### Product Information Notice

CMC 1.5" Single ProSwivel™ Pulley

Part Number: 300431-02

Serial Number: 25064M & 24338M

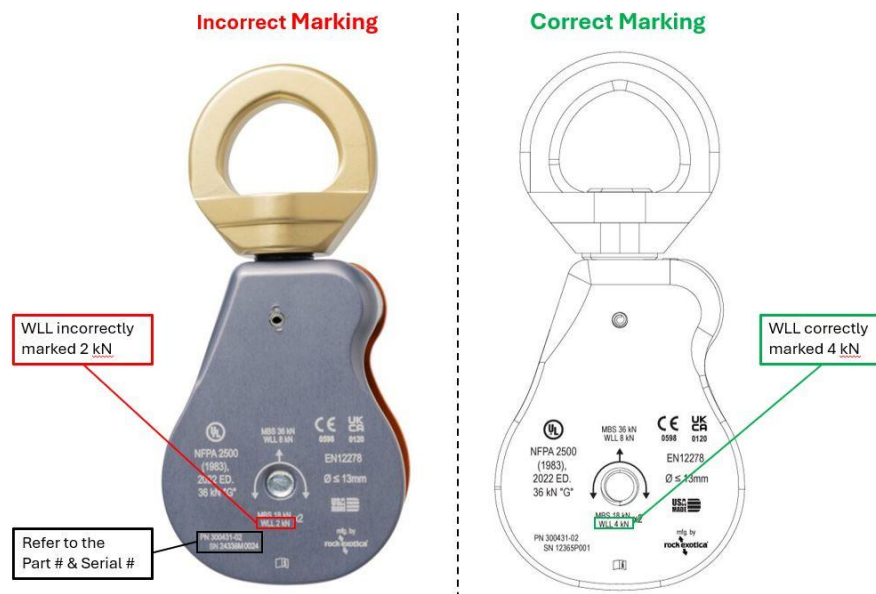
Through our internal inspection process, we identified a misprint in the Working Load Limit (WLL) markings for the rope path on the 1.5" Single ProSwivel Pulley with Part Number 300431-02 and Serial Numbers 25064M and 24338M. The correct marking is 4 kN for each rope path, while the mismarked pulleys show a more conservative marking of 2 kN. Please refer to the illustrations below.

All CMC 1.5" Single ProSwivel Pulley units that have this marking issue are within the design specifications and can remain in service. CMC and Rock Exotica have corrected this issue for all current and future pulleys available from our inventory. If you have any questions about this Information Notice, please contact CMC Customer Support at 800-513-7455.
